JANNAH VILLAGE - PHASE 3

CITY PROJECT NO. 14856
CONTRACT NO. 9352

REVISION 1 - 08/28/24
- Updated Sheets: U1-U4, U7-U8, W3-W4

14856
W-2

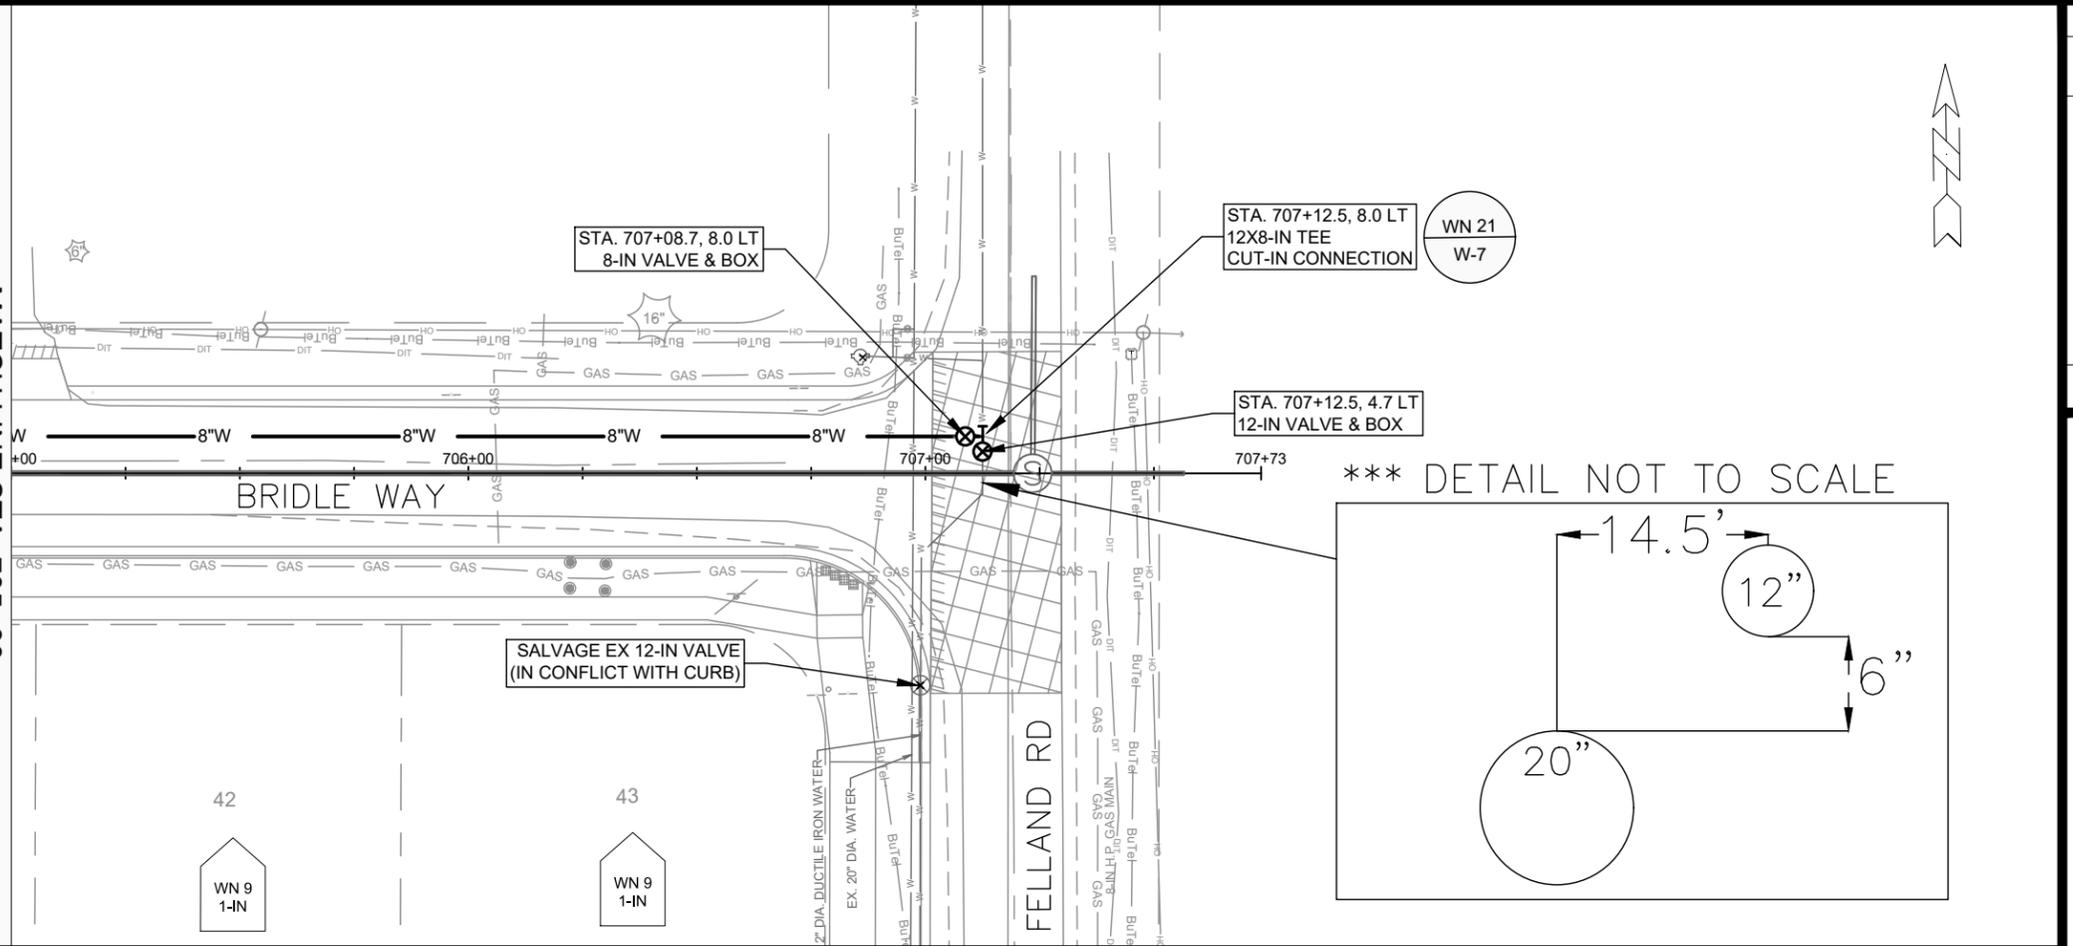
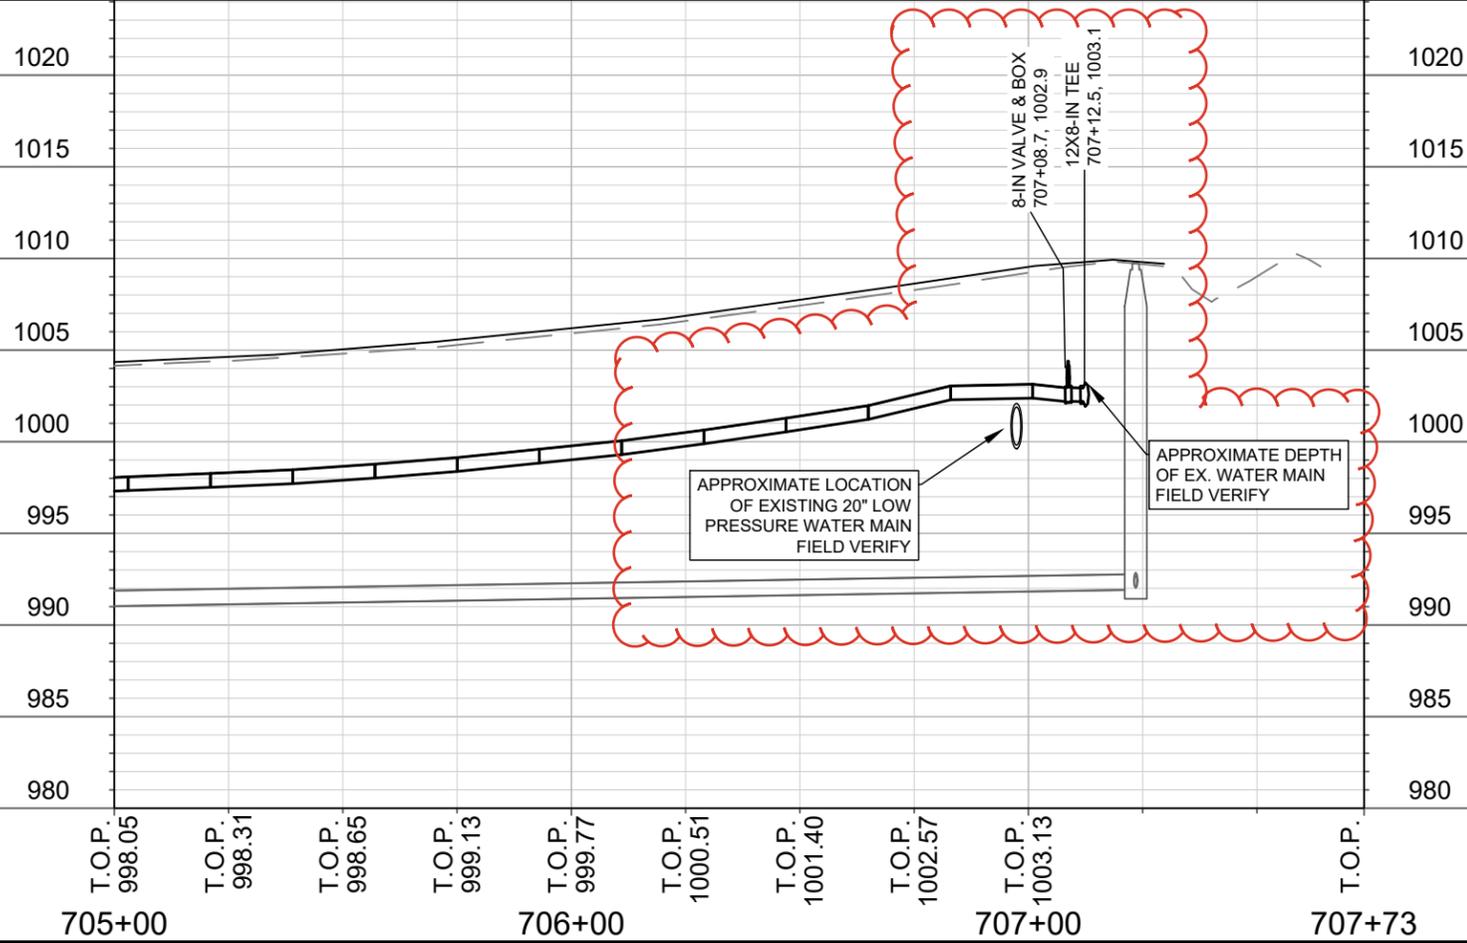
REV 1 - 8/27/24 - RJN
 - Revised water main in Felland intersection from ULO data

14856
 W-3

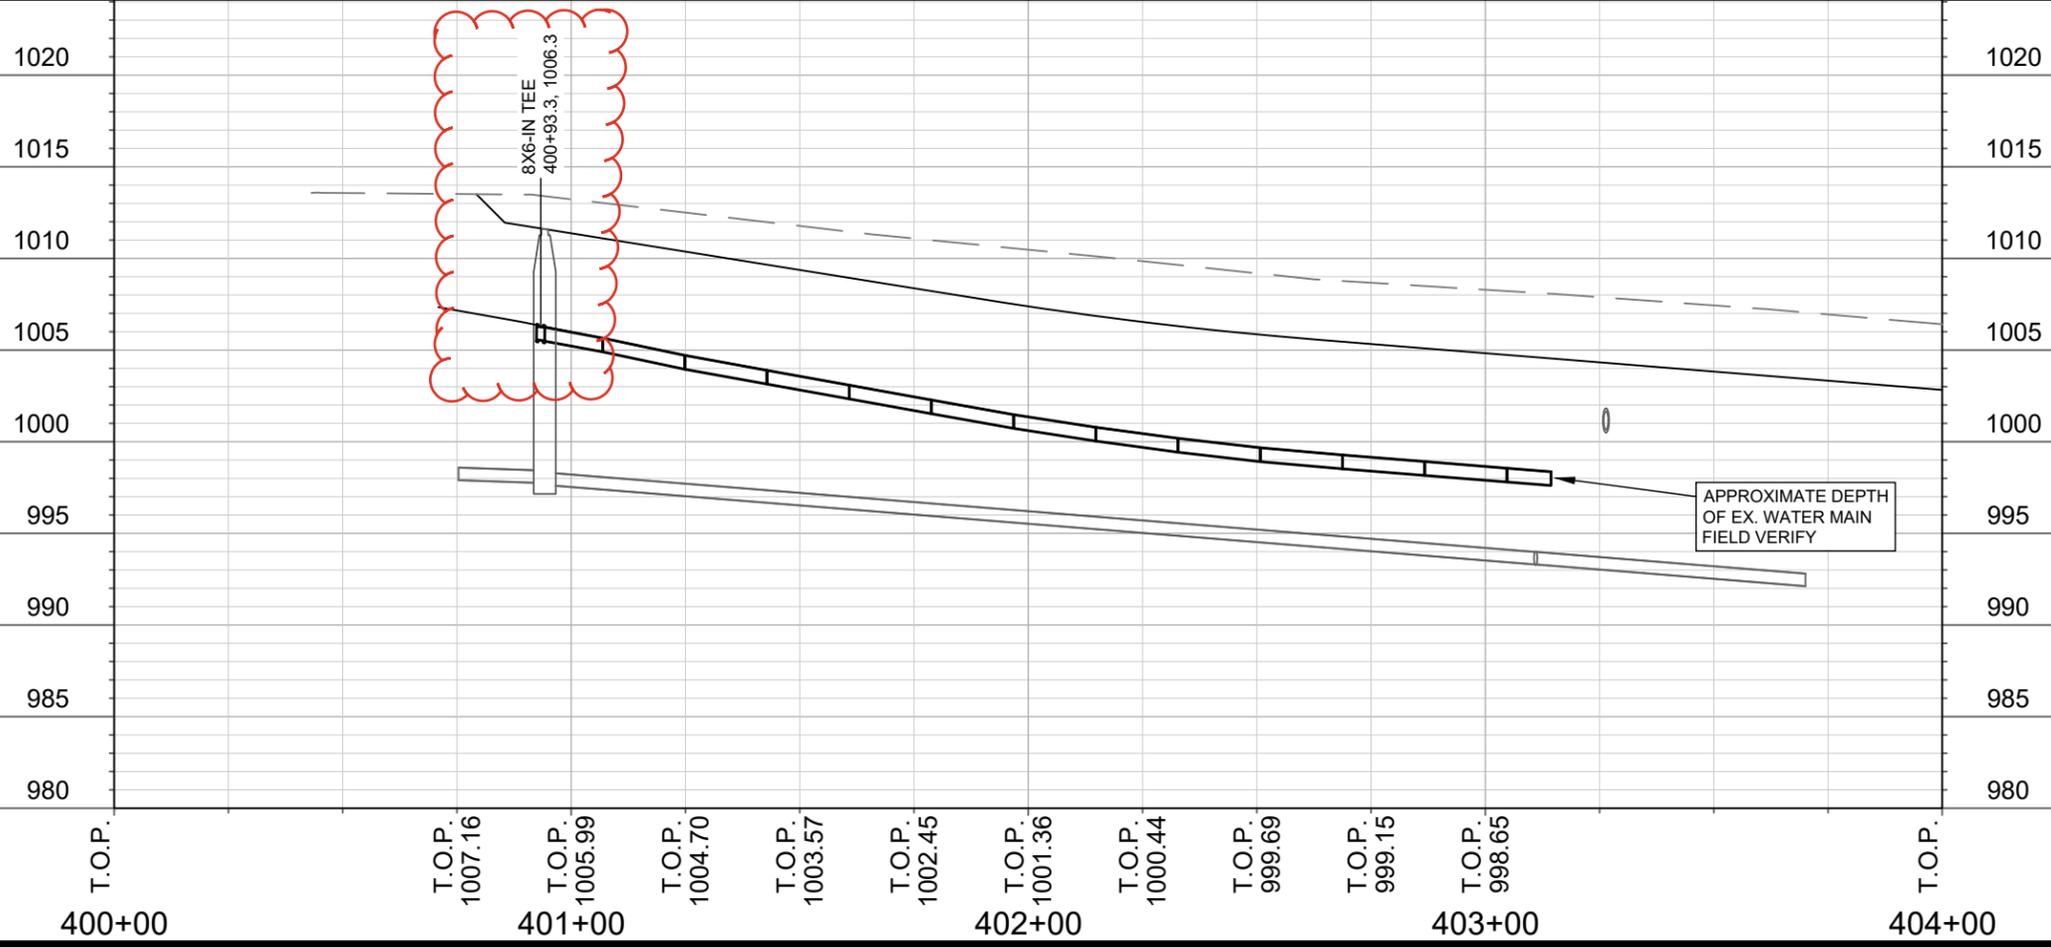
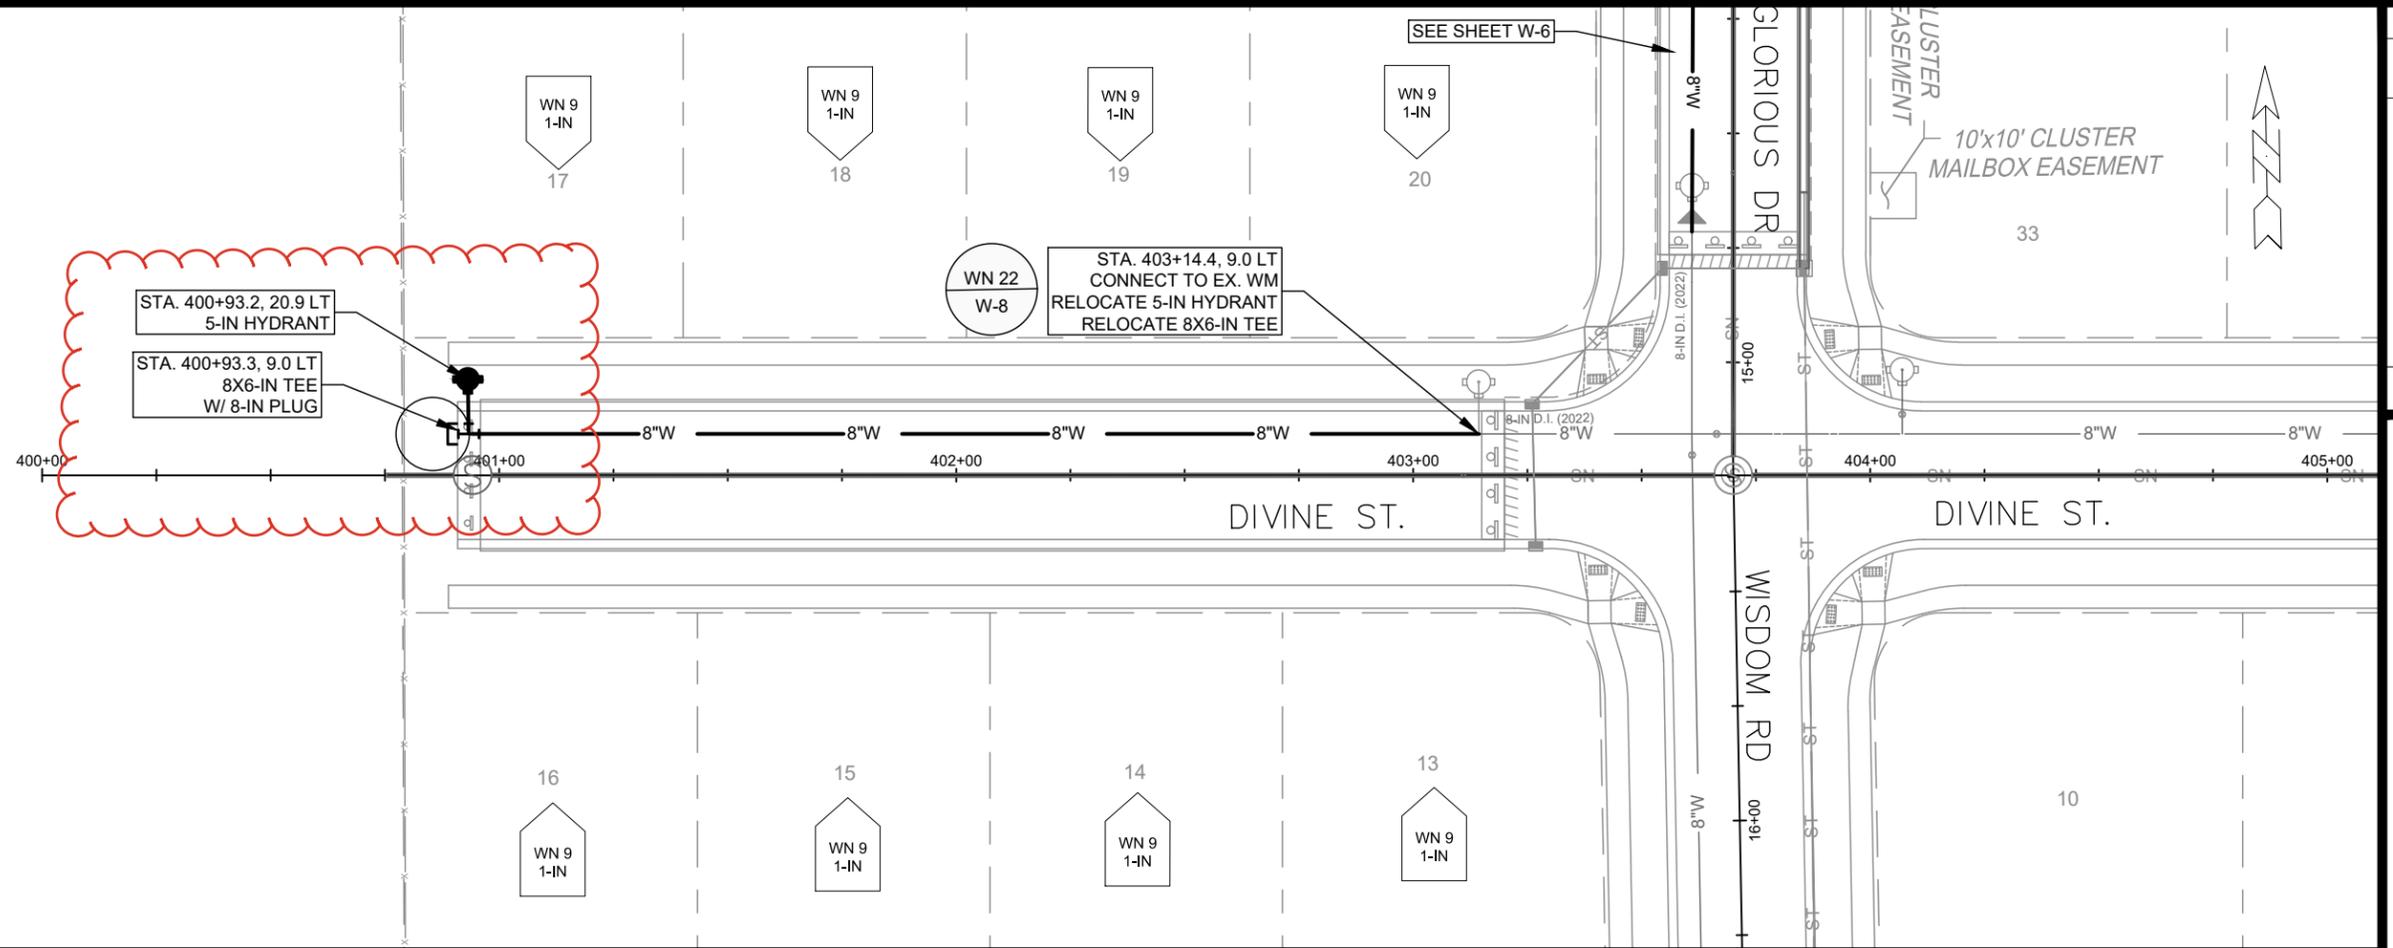
REV 1 - 8/27/24 - RJN
 - Moved hydrant & tee 8 ft east
 due to town of Burke tree
